November 20, 2012

Homestead Nursing & Rehabilitation Center Addition
4735 South 54th Street
Lincoln, Nebraska

ADDENDUM #1

1 HALF-HIGH WALL SECTION
 AD 01 1 1/2" = 1'-0"

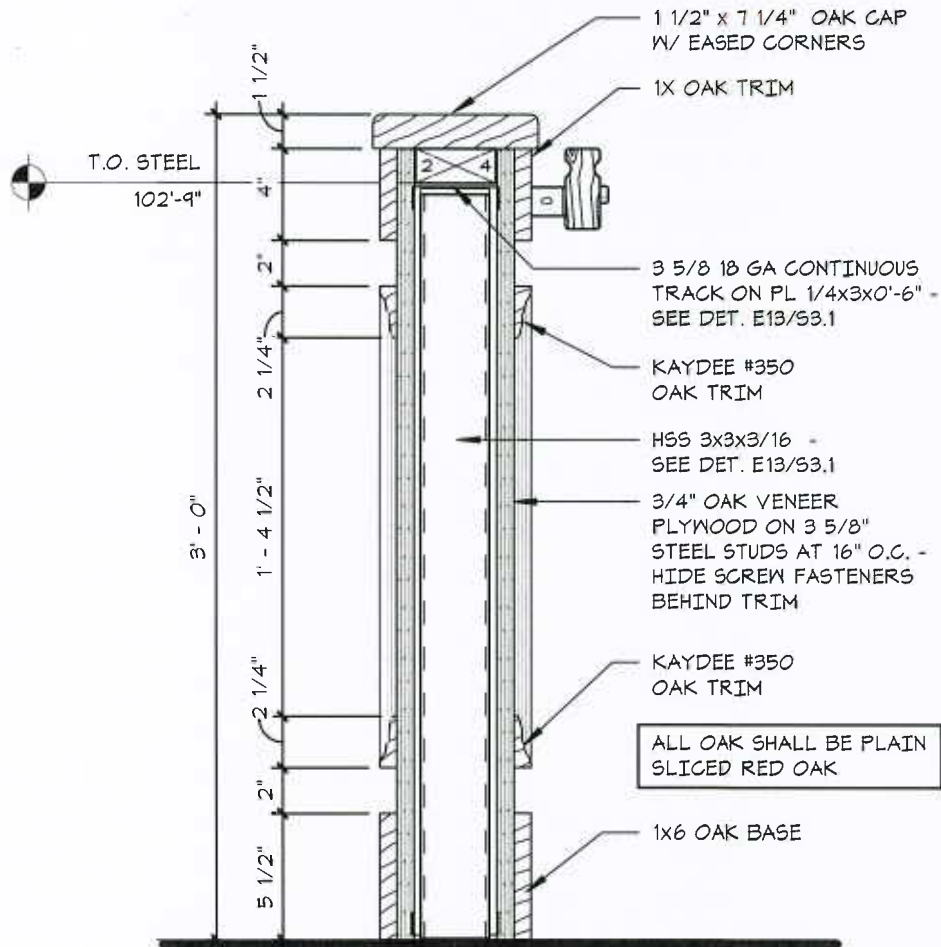
- A. See attached section (Sheet AD 01) through the 3'-0" high walls faced with oak paneling shown on elevations 16, 17 and 18.

ELECTRICAL SITE PLAN

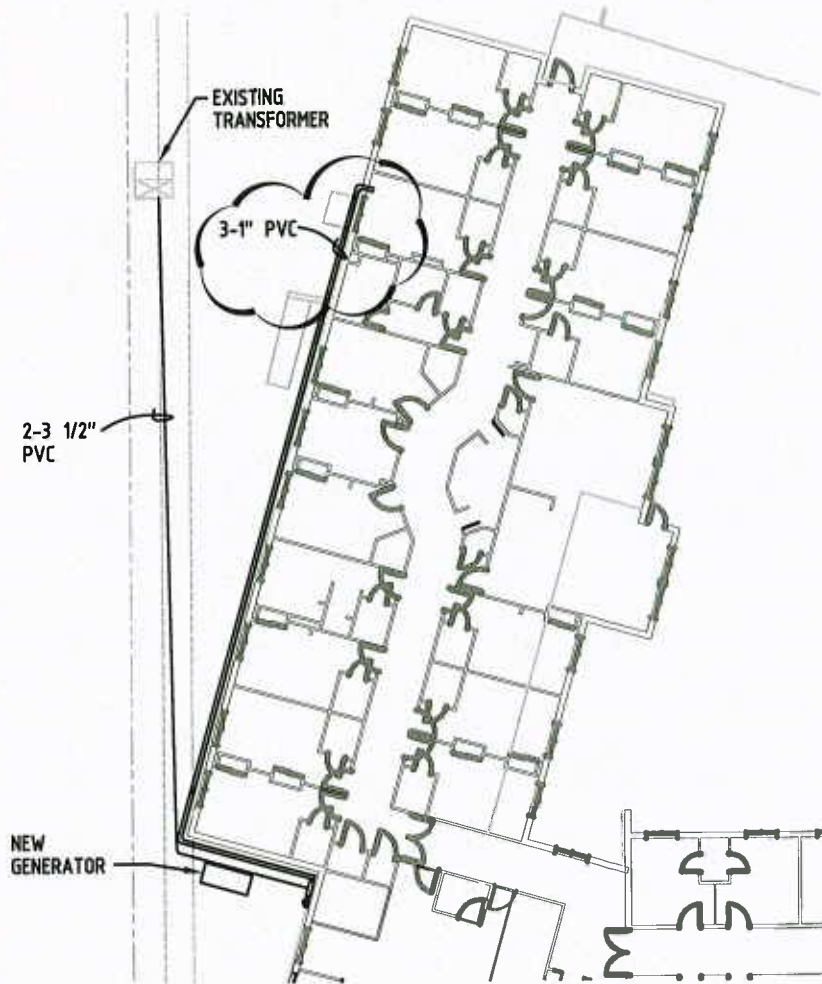
- A. See the attached drawing E0.1 1 of 1 for addition of a third 1" PVC conduit.

1 **FIRST FLOOR ELECTRICAL**
E2.1 **PLAN - WING 2**

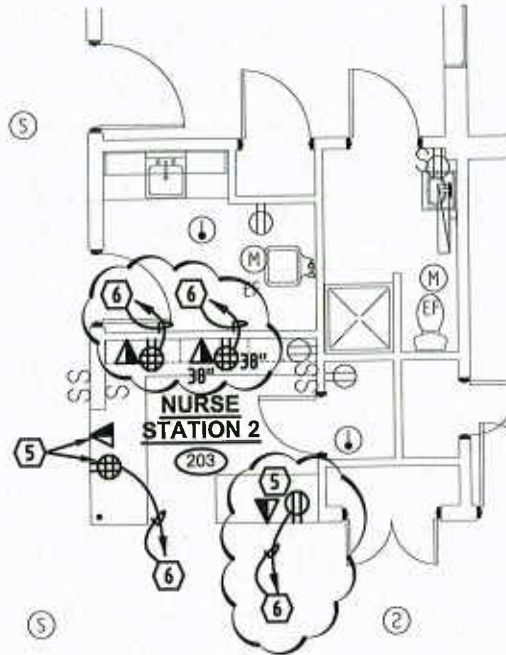
- A. See the attached drawing E2.1 1 of 1 for changes at nurse station #2.
- B. See the attached drawing E2.1 2 of 1 for changes to service grounding.

- 5. COORDINATE EXACT MOUNTING HEIGHT WITH MILLWORK.
- 6. ROUTE TO NEW 20/1 BREAKER IN NEAREST EXISTING PANEL. PROVIDE ALL TERMINATIONS AS REQUIRED.

2 BASEMENT LIGHTING PLAN - WING 4

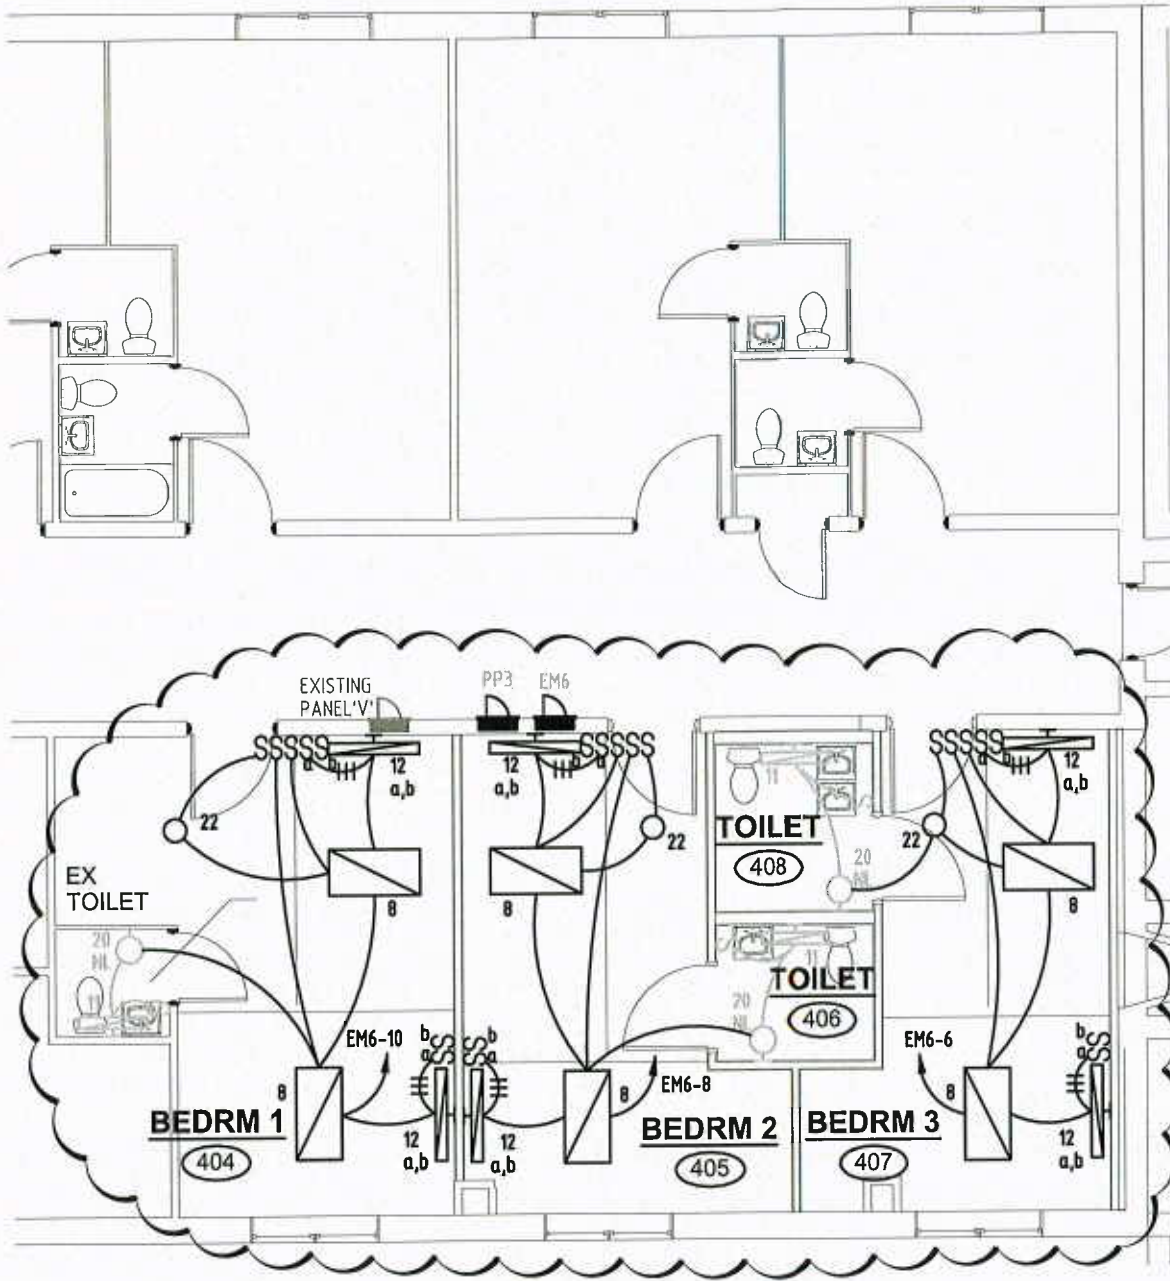
- A. See the attached drawing E2.2 1of1 for changes to Basement Wing 4 Bedrooms 1, 2 & 3.
- B. See the attached drawing E2.2 2 of 2 for changes to Basement Wing 4 Bedrooms 1, 2 & 3.

1 ELEC. ONE-LINE DIAGRAM

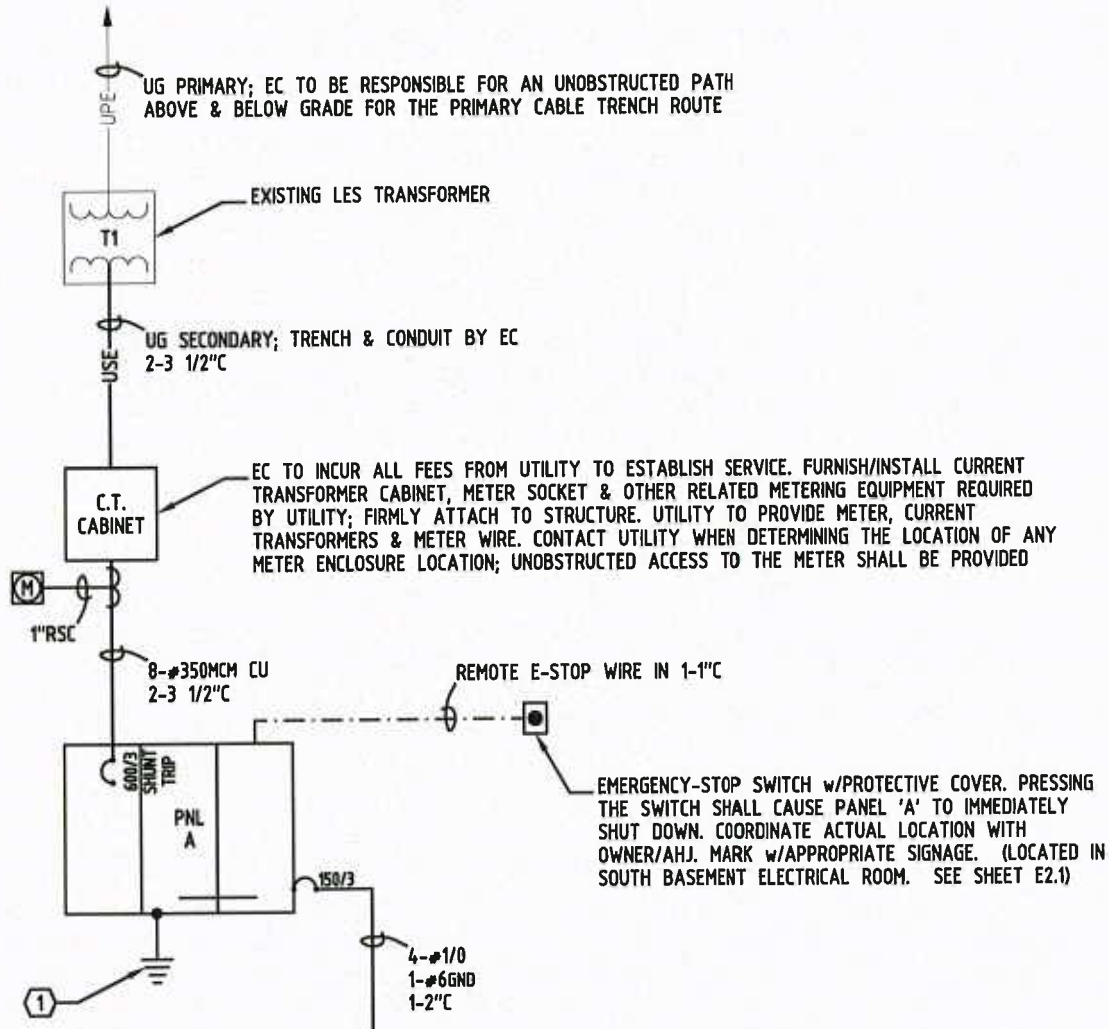
- A. See the attached drawing E4.1 1 of 1 for new grounding and bonding notes.

- ELECTRICAL SYSTEM SHALL BE GROUNDED & BONDED PER NEC. BOND TO EXISTING ELECTRICAL SERVICE LOCATED IN WING 5 BASMENT WITH 1-#3/0 GND IN 1".
1-#4 BARE CU CONDUCTOR TO CONCRETE ENCASED ELECTRODE, SEE CONCRETE ENCASED ELECTRODE DETAIL
